# CITY OF ALBUQUERQUE

**RE: Lot 17 Block 4 Unit 19 SAD 227  
6815 Rim Rock NW  
Volcano Cliffs Subdivision  
Grading and Drainage Plan  
Engineers Stamp Date; 12/11/18 (D10D015)  
Pad Certification Date; 1/29/19**

## DRAINAGE AND TRANSPORTATION INFORMATION SHEET (REV 6/2018)

ENGINEER'S SEAL	Title 6815 Rim Rock Road  GRADING AND DRAINAGE PLAN	DRAWN BY
 12/11/18  Richard Dourte P.E. #10854		DATE
		SHEET #  1 of 1  JOB #

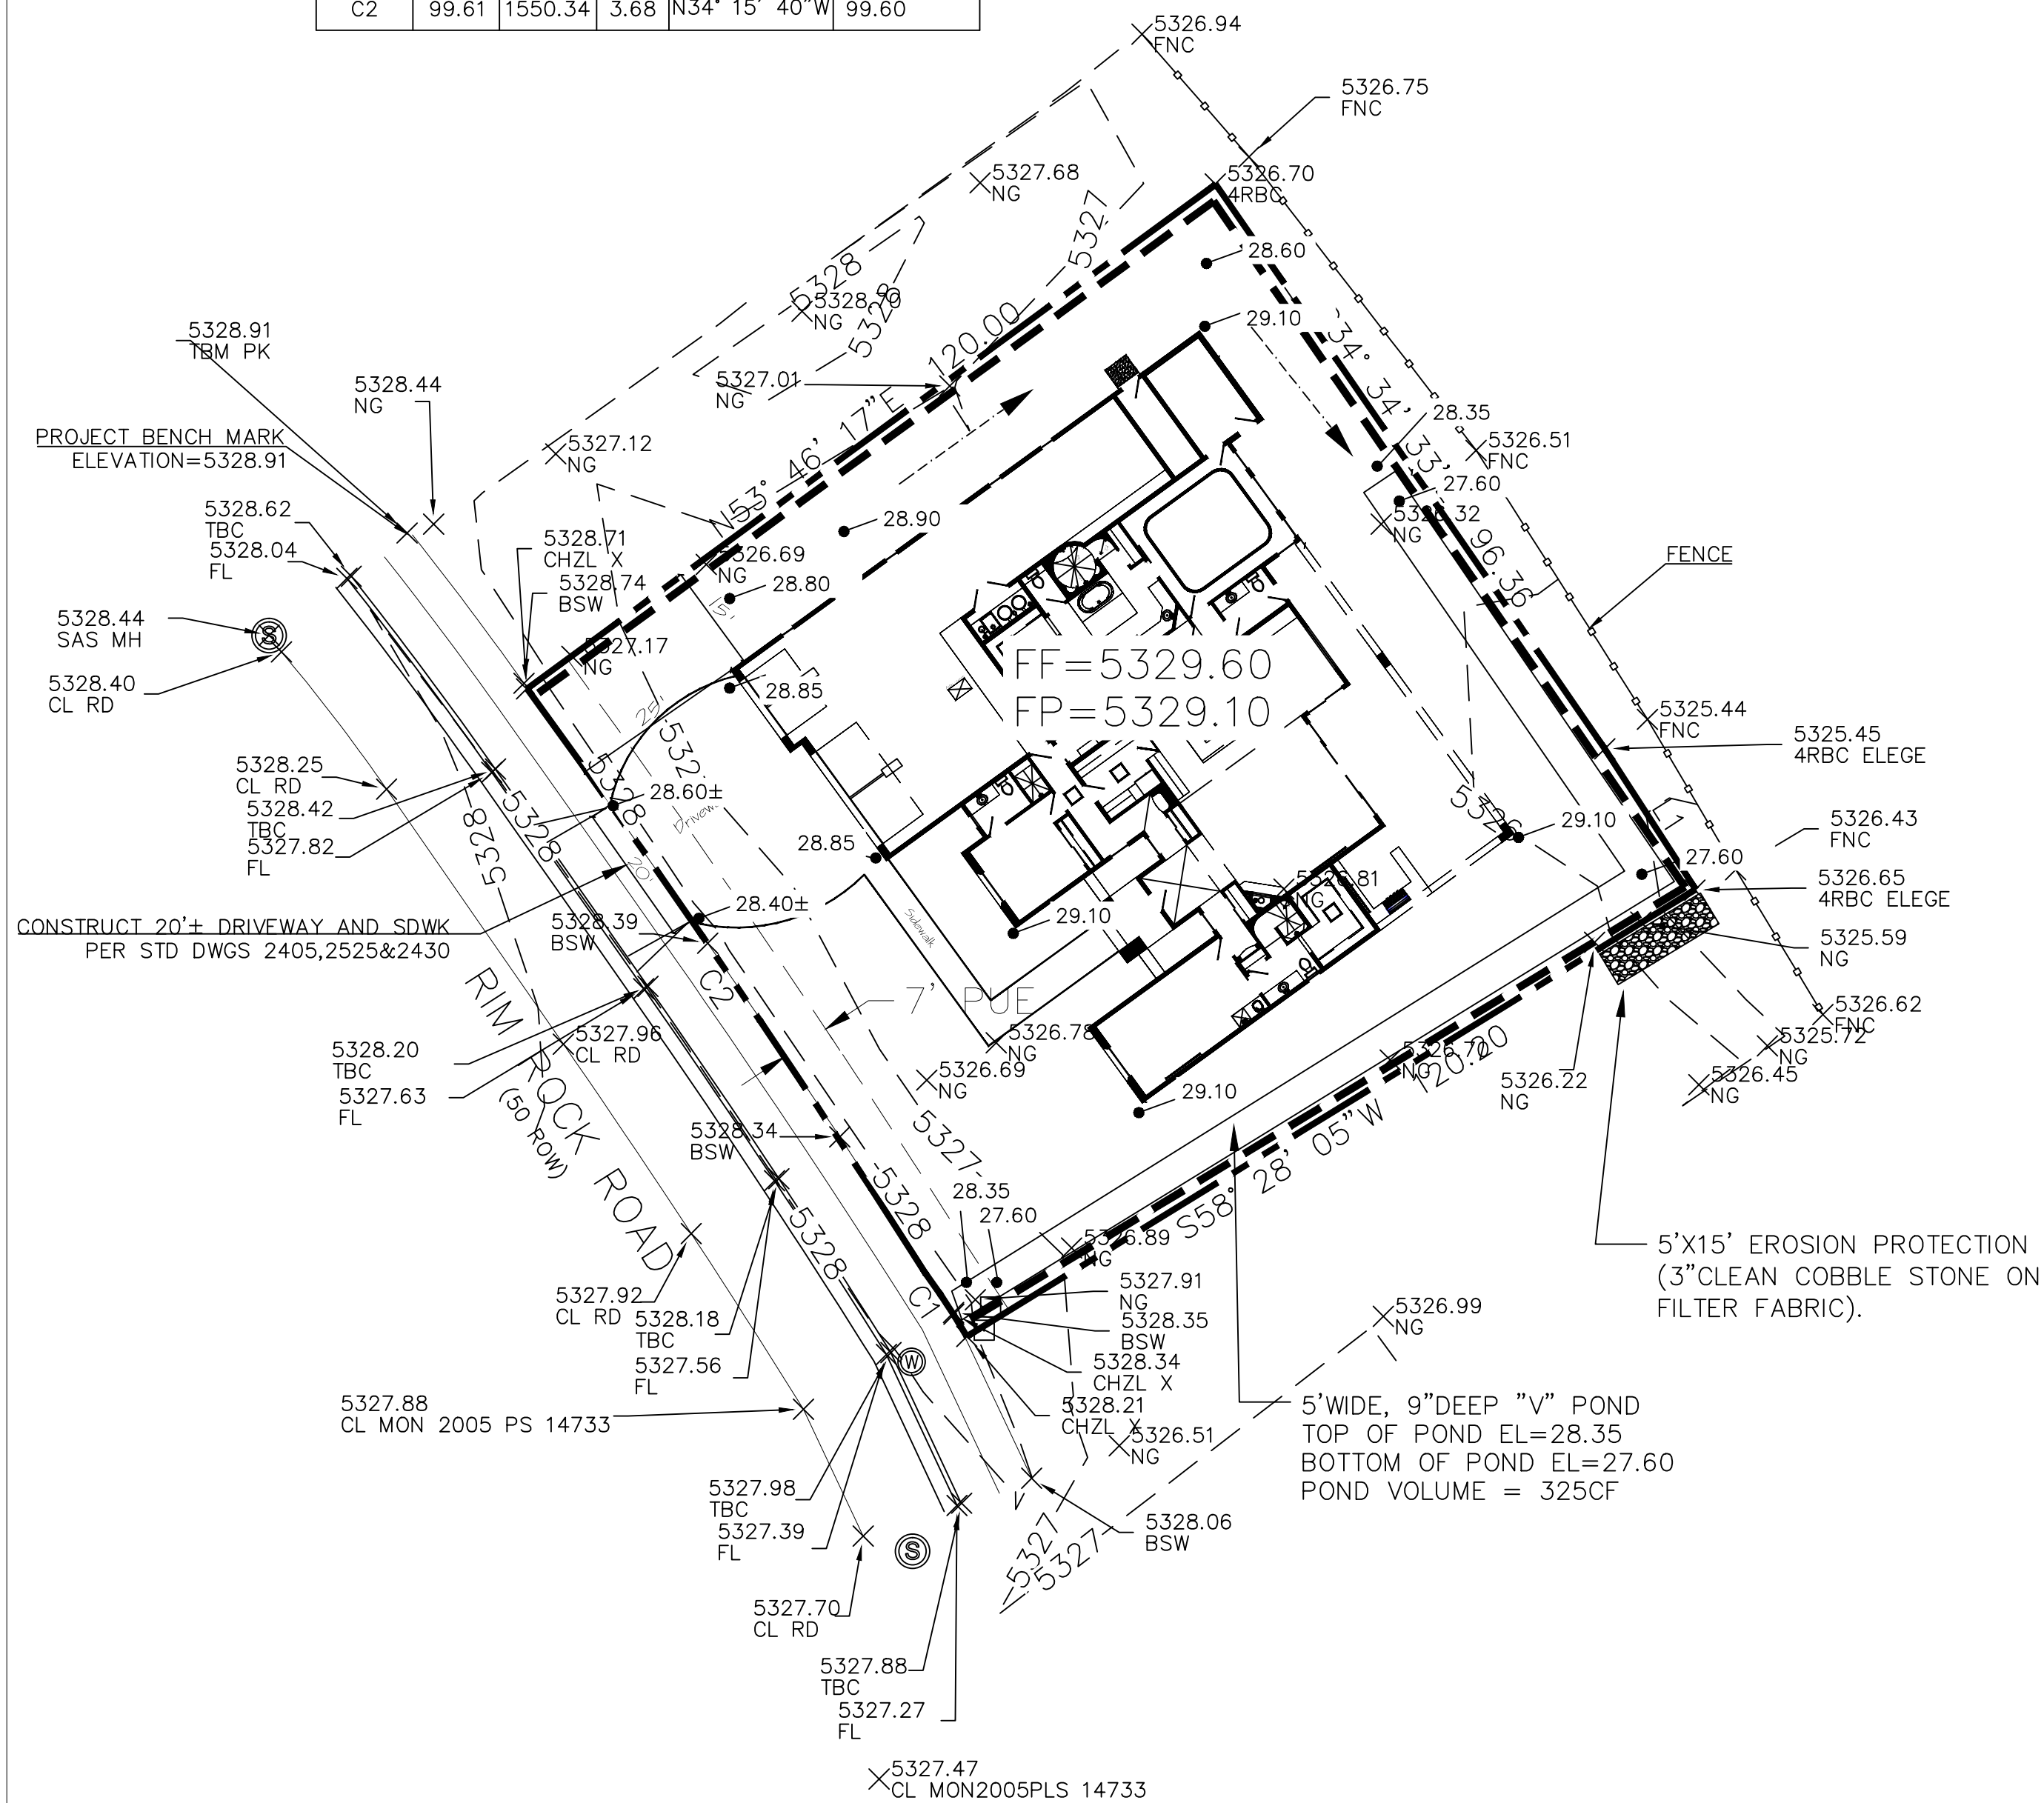
Based upon the information provided in your submittal received 1/31/19, this plan is approved for Building Permit.

Reiterate to the Owner/Contractor that a separate permit for a garden/retaining wall must be obtained, with the approved G&D plan.

Prior to Certificate of Occupancy release, Engineer Certification per the DPM checklist of this plan will be required.
